STAFF RECOMMENDATION

114 Lindsley Park Drive

May 17, 2017

Application: New construction-infill

Figure 1: Lindsley Park Addition Subdivision (1925)

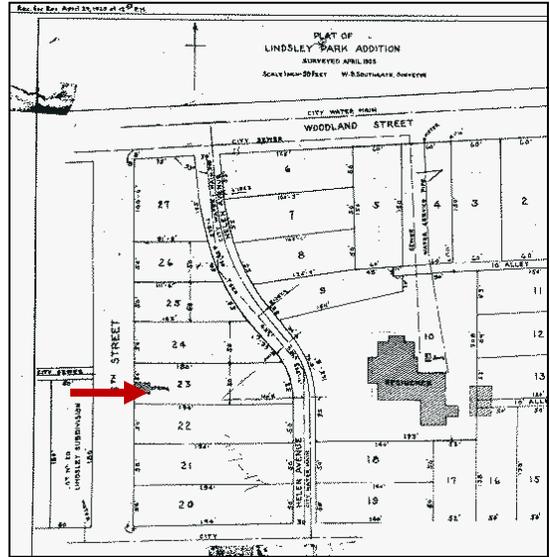
Background: The area that is now Lindsley Park Drive was initially the driveway to the Adrien V. S. Lindsley’s 1840, Italianate style, Springside Mansion. A Union supporter, Lindsley permitted his estate to serve as an unofficial headquarters for generals George Thomas and James Wilson during the Civil War. Beginning in 1887, owners of large estates in the area began to subdivide and sell off their land holdings. The property located at 114 Lindsley Park Drive is lot no. 23 of the Lindsley Park Addition Subdivision recorded in 1925. (Figure 1). At that time Lindsley Park Drive was Helen Drive.

SOUTH ELEVATION - 114 LINDSLEY PARK

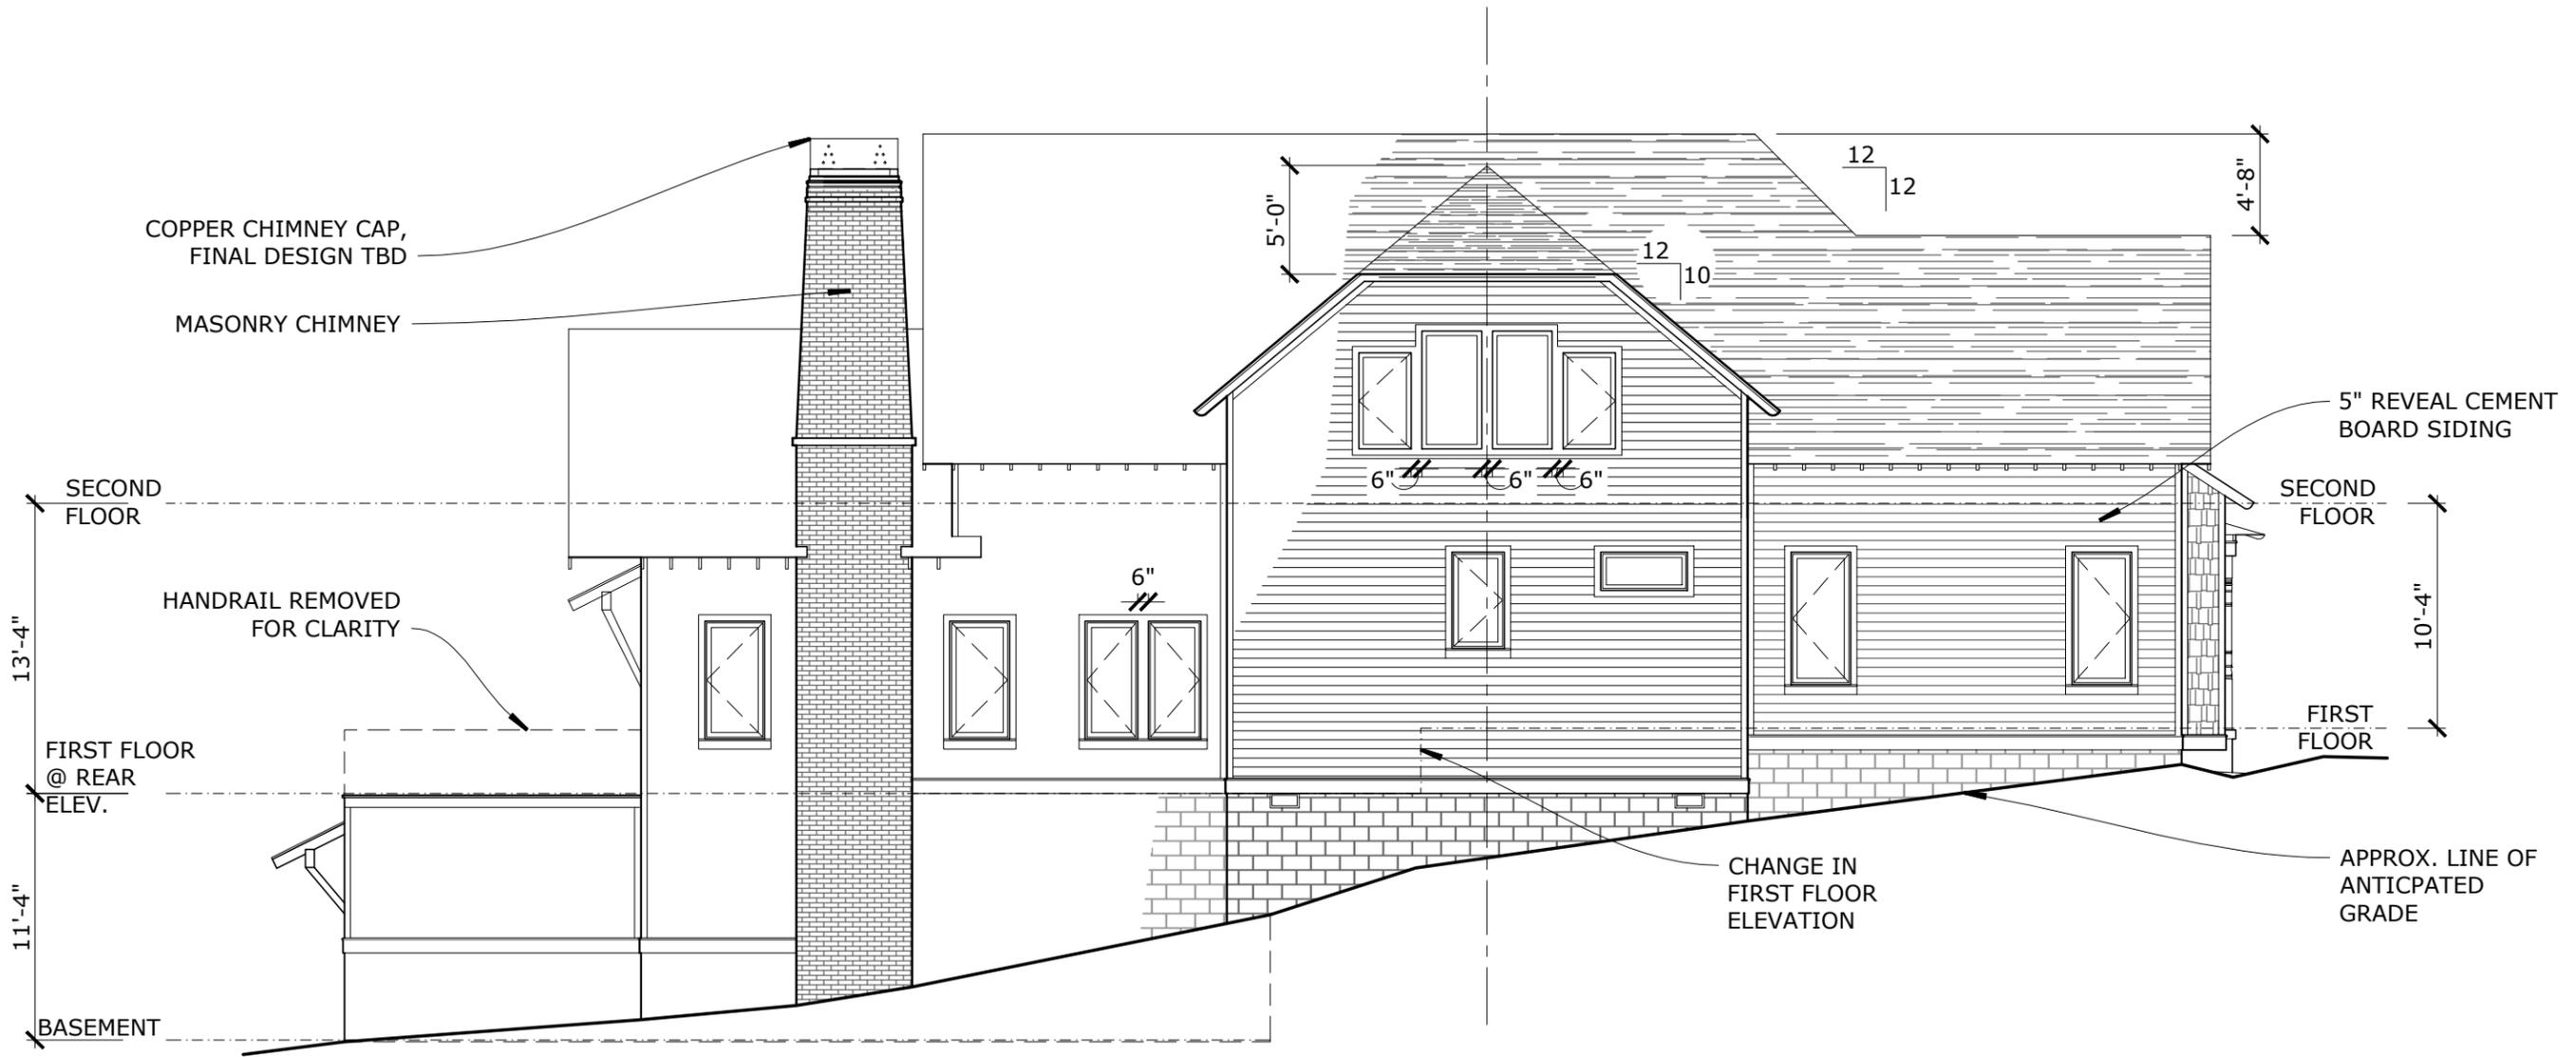
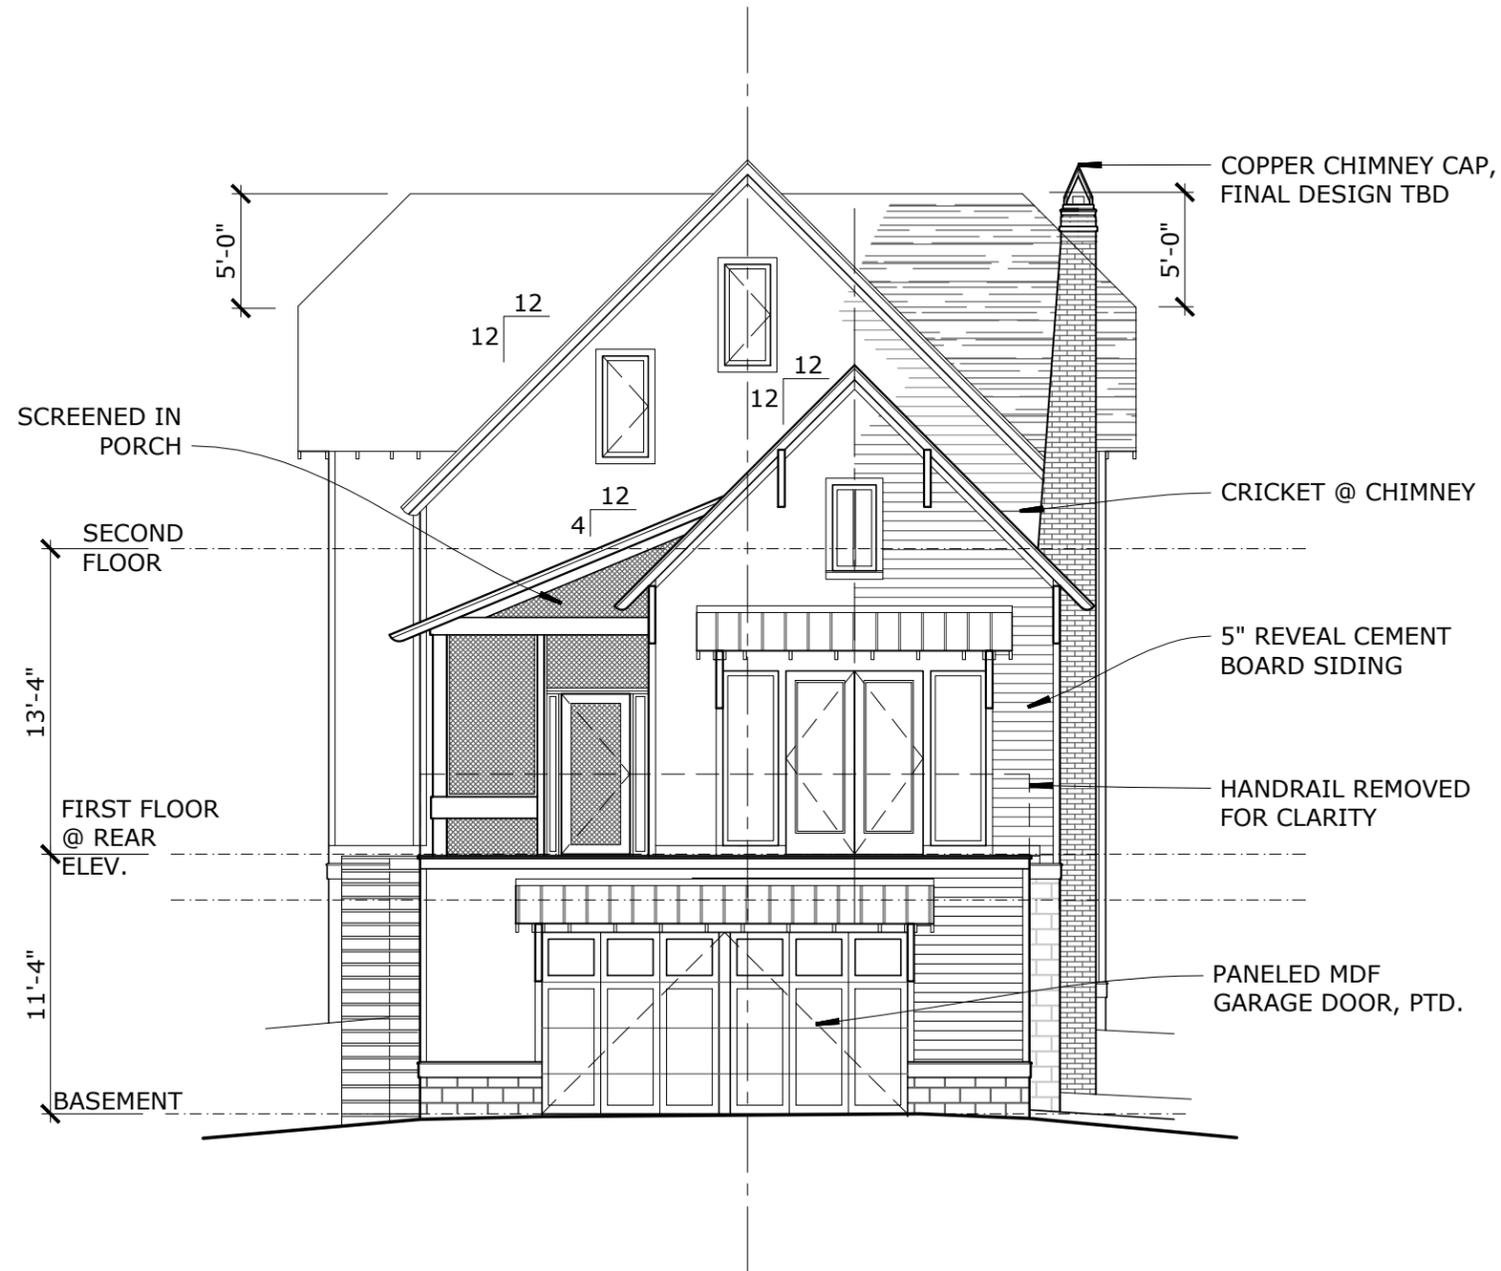
There are three eave heights readily visible from the front: projecting bay, middle massing and central cross-gable. Previously the middle massing and projecting bay had eave heights of approximately seventeen feet (17') from finished floor. The projecting gable and middle massing are now approximate twelve feet (12') from finished floor. This was accomplished by lowering the ceiling heights from 10' on the previous proposal to 9' with a 30" knee wall. (The overall massing is also controlled by changing floor levels on the interior of the house.) The third component, the cross gable, extends beyond the two side walls and has an eave height of sixteen feet (16') from the front grade. Although this eave height is tall for a one and one-half story building the cross gable reads more as a projecting bay, rather than a principal massing. It does not begin until approximately twenty-feet back from the front wall on the left side, its closest point, and is only approximately twenty-three feet (23') wide. The overall eave and ridge heights are further mitigated by a projecting front bay with a low eave height, a wrap-around porch which pushes some of the massing towards the middle of the building, the break-up of the roof massing into smaller components and the fact that the house sits lower than the street.

Proportion and Rhythm of Openings: Most of the windows on the proposed infill are generally twice as tall as they are wide, thereby meeting the historic proportions of openings. The plan includes a smaller horizontal window on the left side façade. Staff, however, finds that this window could be appropriate given its location and the change in grade on site as it will not likely be visible from the street. There are no large expanses of wall space without a window or door opening. Staff finds the project's proportion and rhythm of openings to meet Section II.B.1.g.

NORTH ELEVATION - 114 LINDSLEY PARK

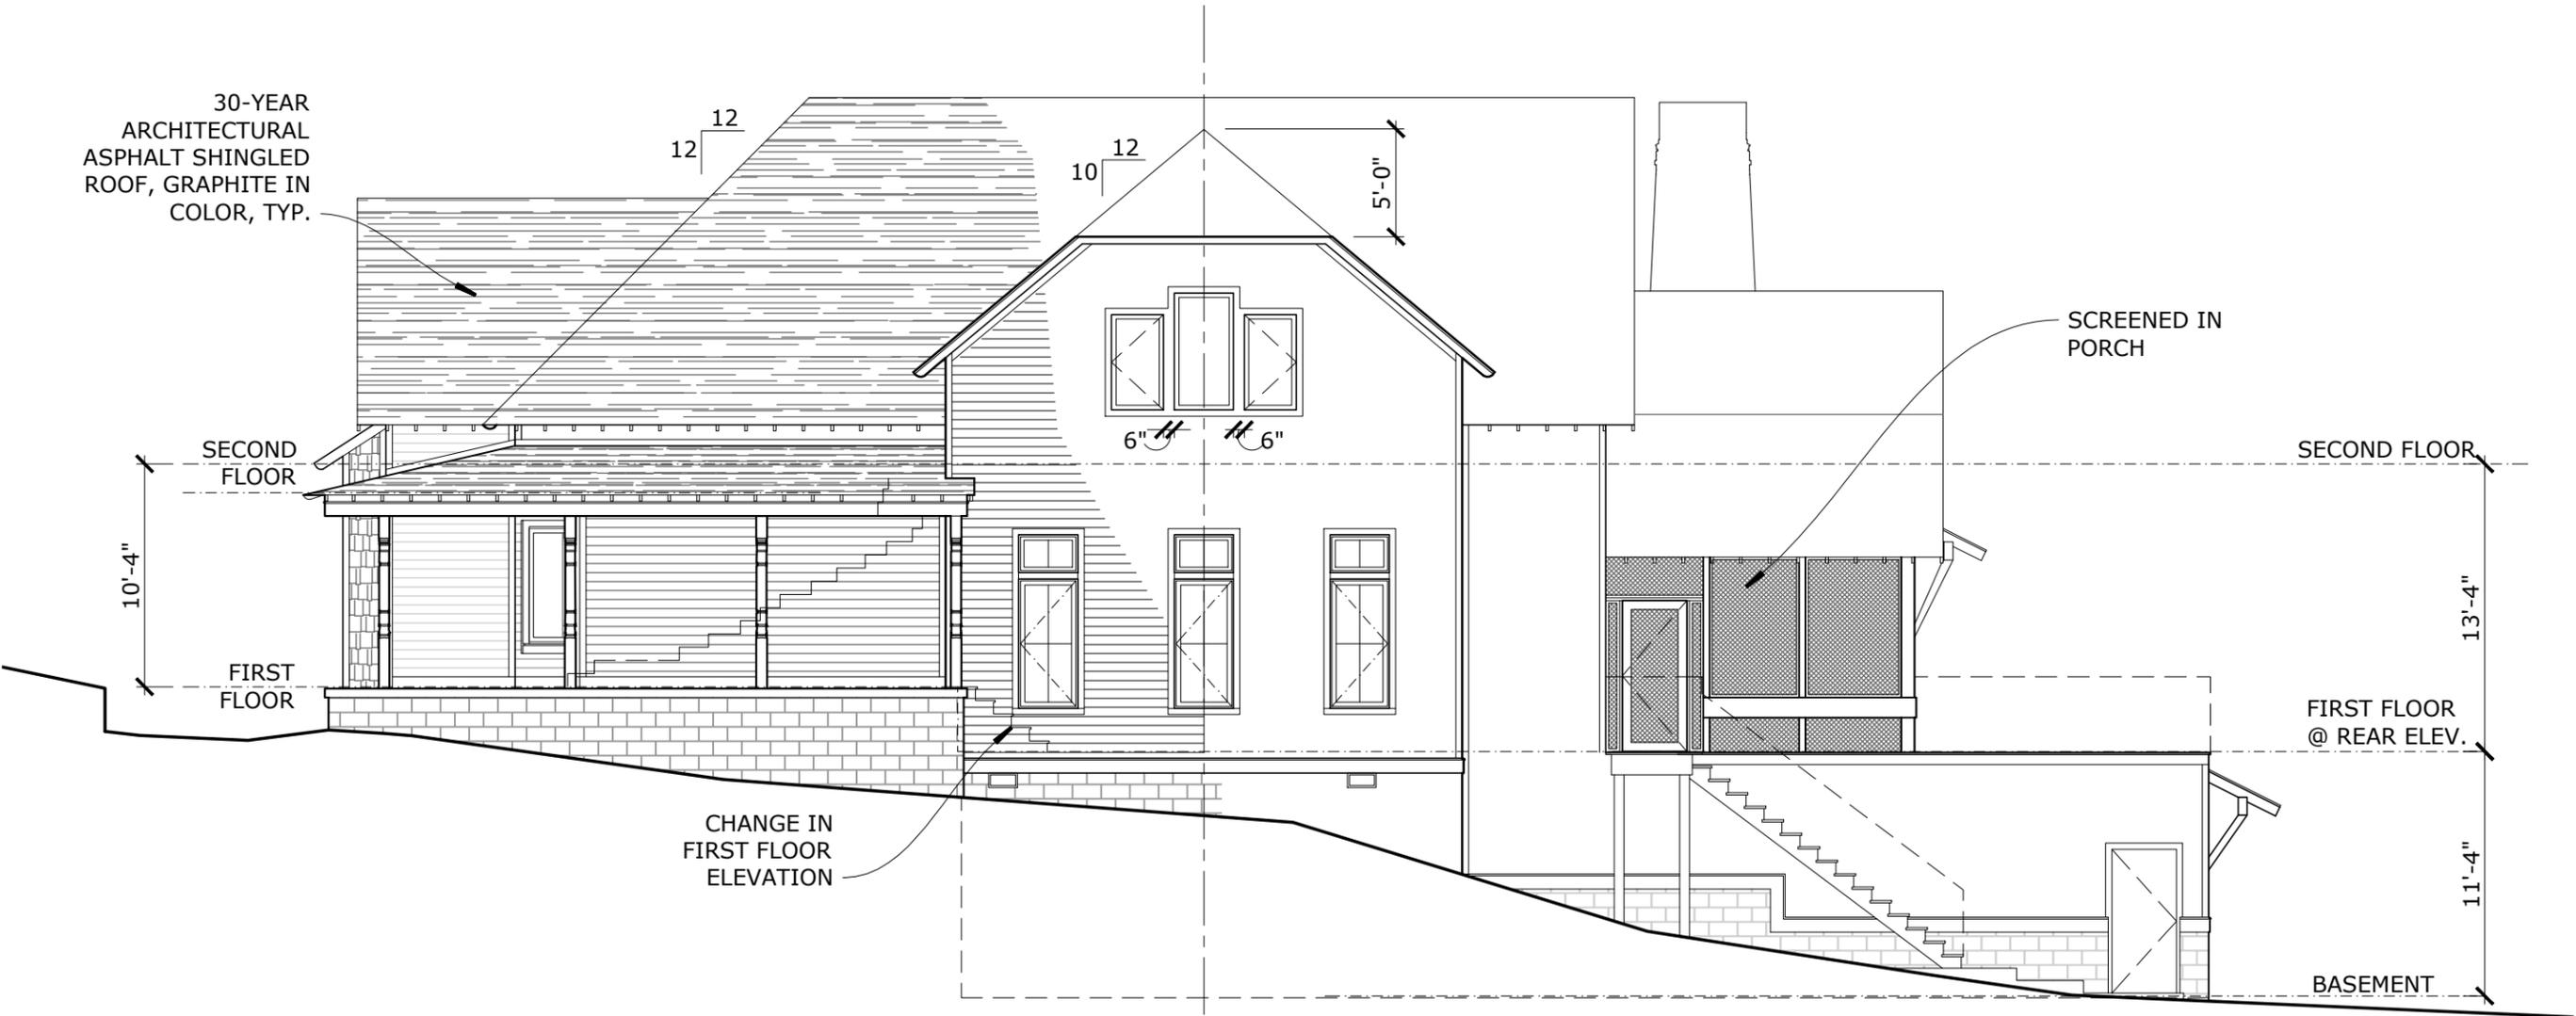
At the rear, facing South Fifteenth Street, the house steps down from three-stories to a single-story. Previously, this first rear-story was fifteen feet (15') tall, the revised drawings have lowered the height to eleven feet four inches (11'4") above grade. The overall height on the rear elevation remains at forty feet (40') above rear grade at its highest point. The elevation steps back twice and this tallest portion of the house is setback twenty-six feet (26') from the garage façade, helping to mitigate the impact of the height.
